World Forum for Harmonization of Vehicle Regulations

Proposal for a Supplement 5 to the 02 series of amendments to UN Regulation No. 90 (Replacement braking parts)

Supplement 5 to the 02 series of amendments to UN Regulation No. 90 (Replacement braking parts)

Paragraph 4., amend to read:

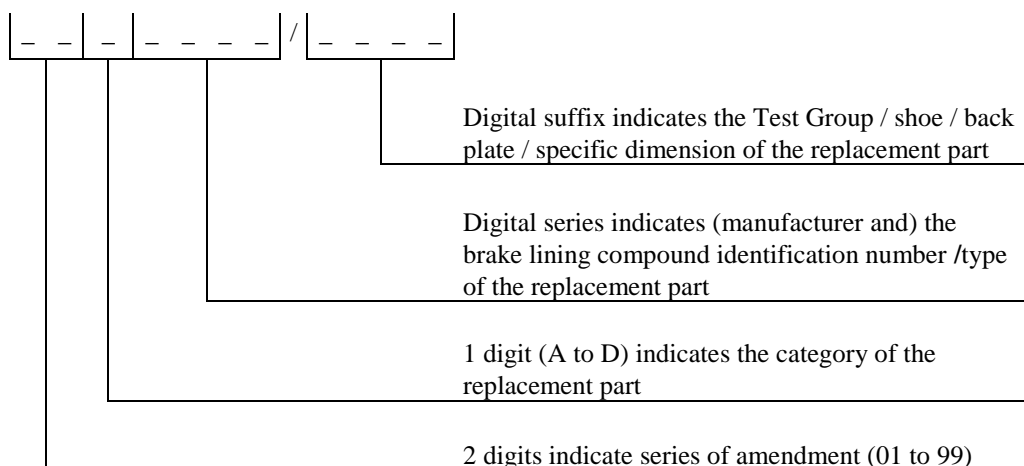
- "4. Approval
- ...
- 4.2. To each replacement part approved there shall be assigned an approval code and an approval number, the latter in the format according to Schedule 4 to the Revision 3 of the 1958 Agreement. The approval code shall comprise four groups of digits:
- ...
- 4.2.3. The next series of digits shall indicate the manufacture and the brake lining compound identification number of the brake lining, the type of disc or the type of drum.
- The digital suffix shall indicate:
- (a) The shoe or back plate or specific dimension in the case of drum brake linings;
- (b) The Test Group in the case of a replacement disc or replacement drum.
- The variants approved as a Test Group shall be listed as an appendix to the communication document:
